EXHIBIT A: Marked-Up Version Of The Amended Paragraph Of The Specification

J.A. ABYS 52-14-6-6

FIG. 2

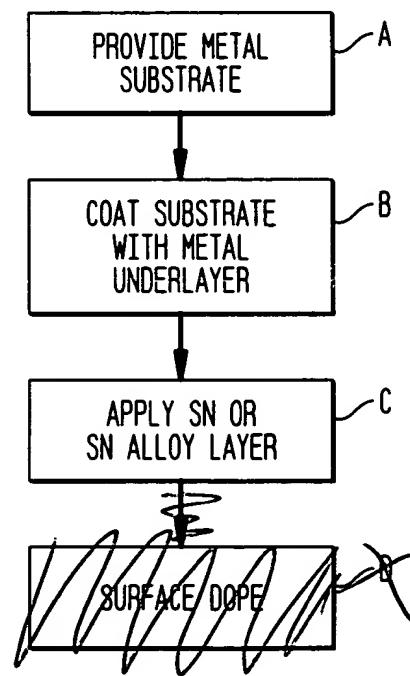
recite "B" in the proper context. In addition, Applicant has amended FIG. 2 to remove "D" and its associated Box reciting "SURFACE DOPE". A corrected version of FIG. 2 is filed herewith.
